**ADDENDUM #1
BL040-25
Lester Woods / Woodview Drive Water Main Replacements**

The following addition/changes modify the Bid No. BL040-25 "Lester Woods / Woodview Drive Water Main Replacements" Contract Documents, dated July 2025, as first advertised on July 16, 2025.

DEPARTMENT OF TRANSPORTATION

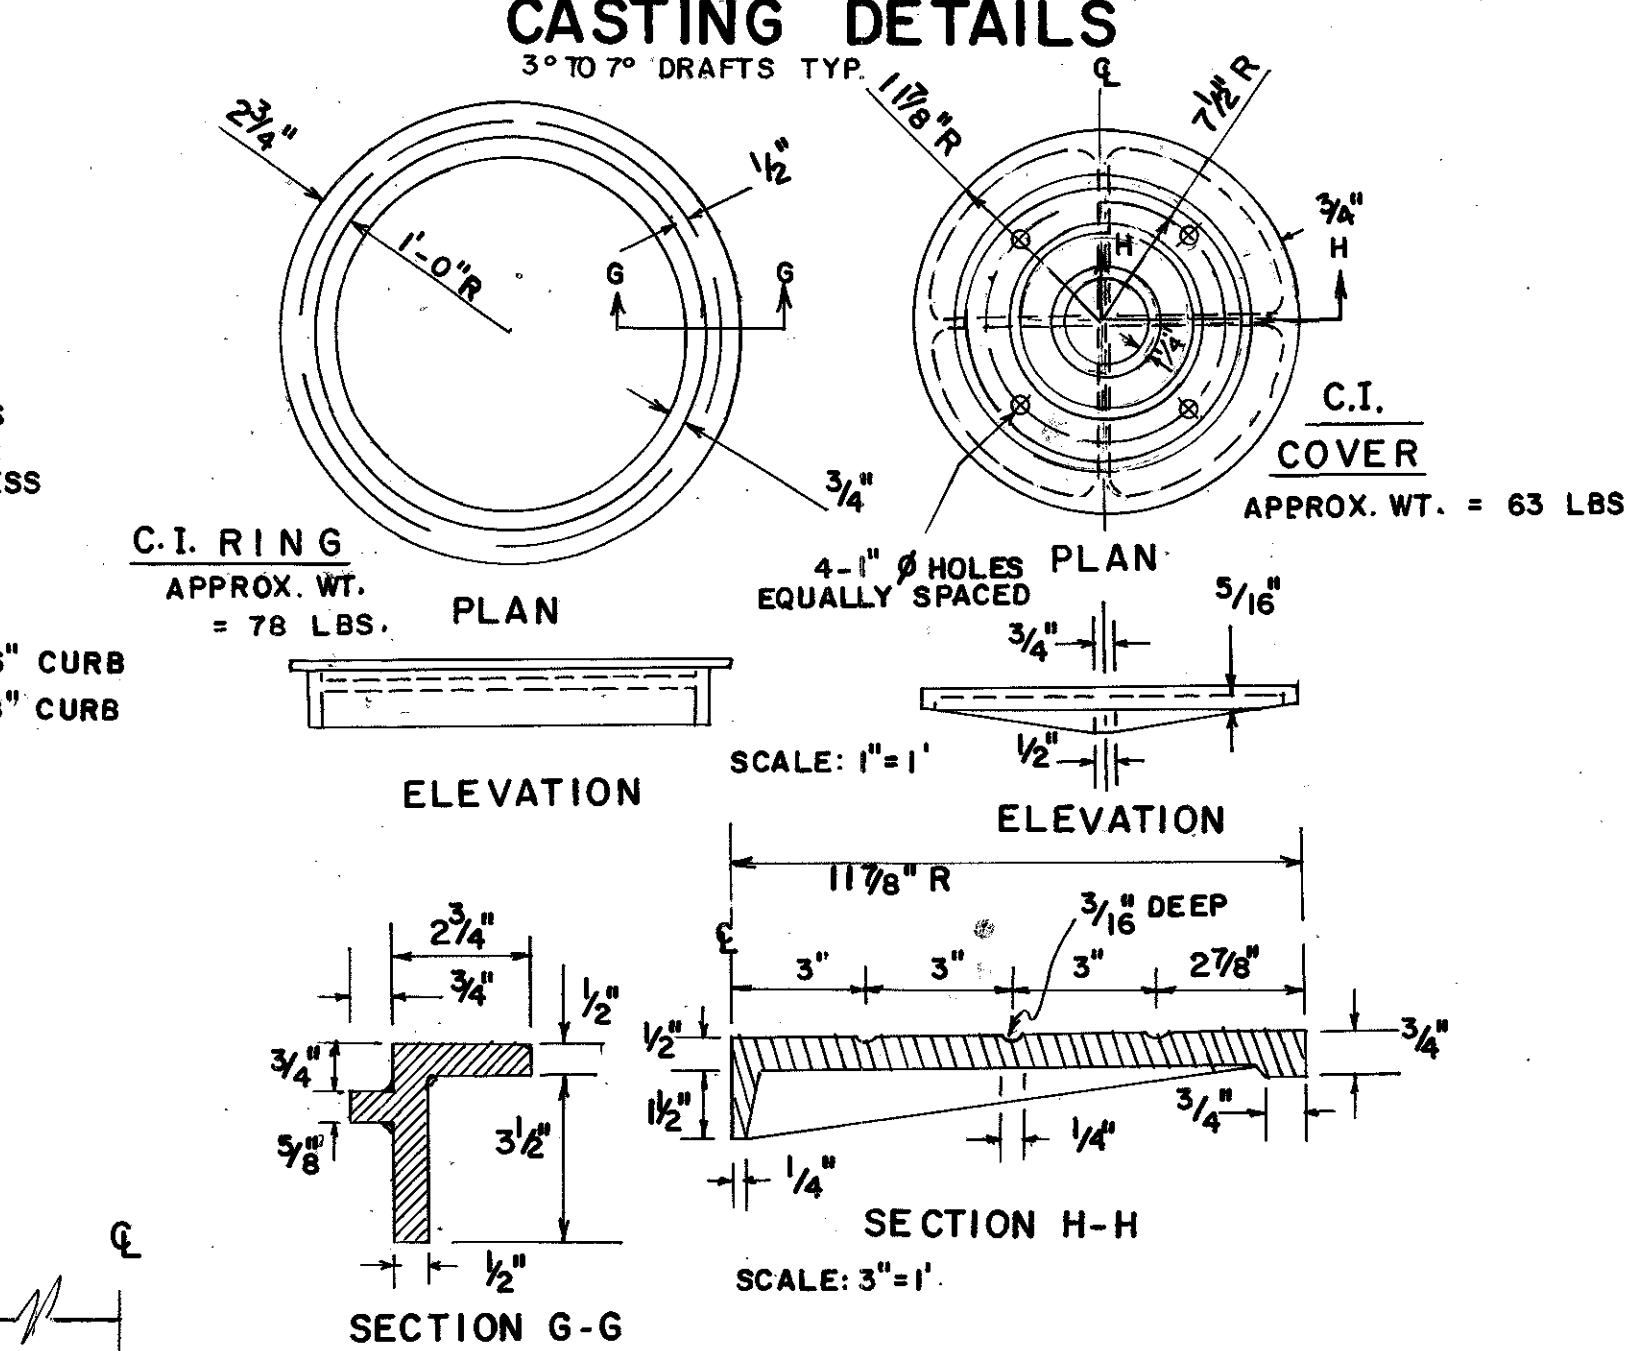
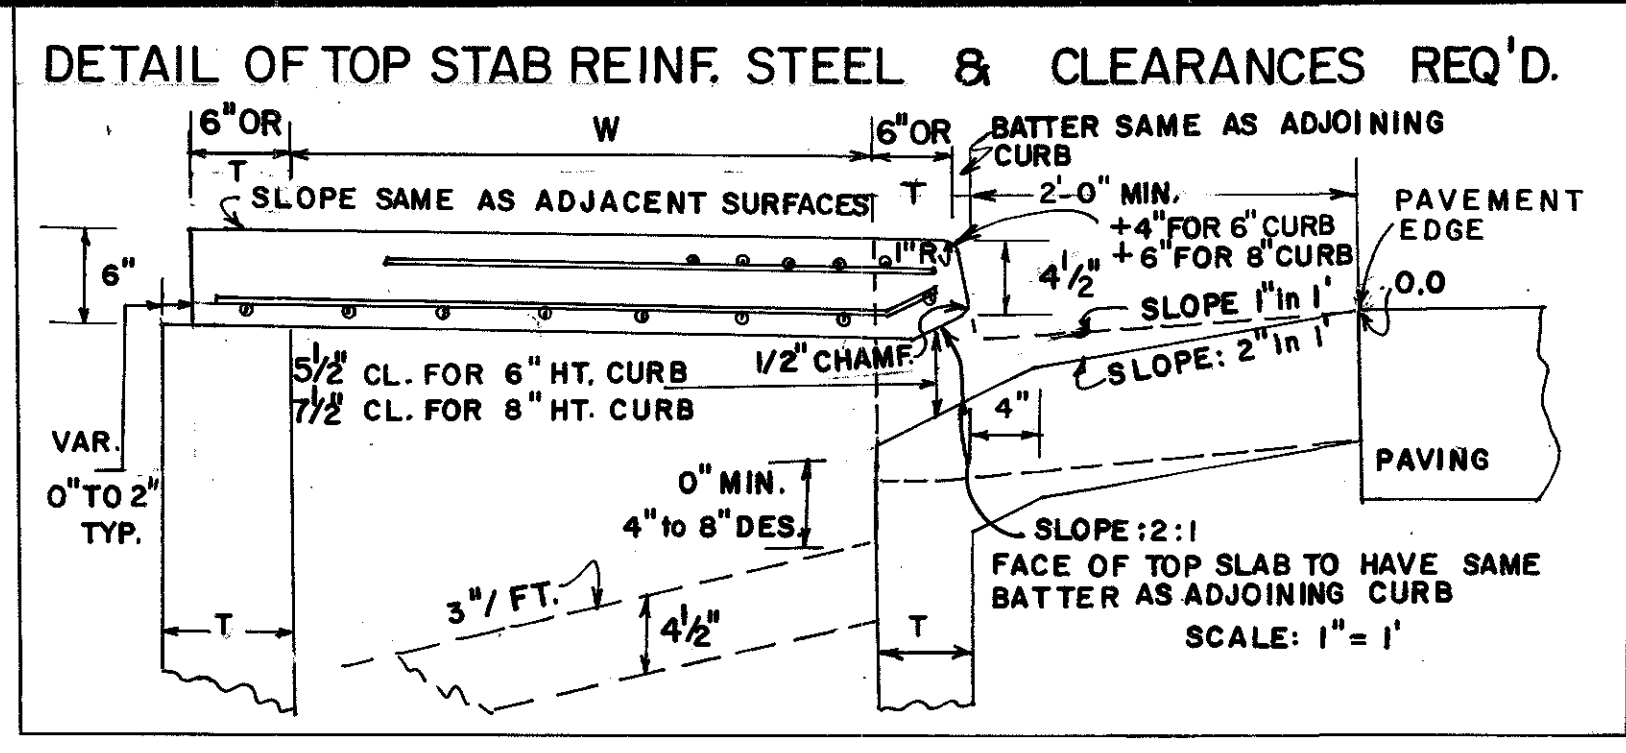
- A8. No, the quantities shown are what the project shall be bid on.
- Q9. Please confirm for bid item 14, that the Catch basins are to be completely removed and replaced with new structures, throats and tops? Can these new structures be bricked up or must they be precast?**

- A9. Please install per GDOT detail 1034D attached.
- Q10. Bid item 19 and 39 are the same for the 16" x 8" Tapping Sleeves and Valves. Is this a mistake?**
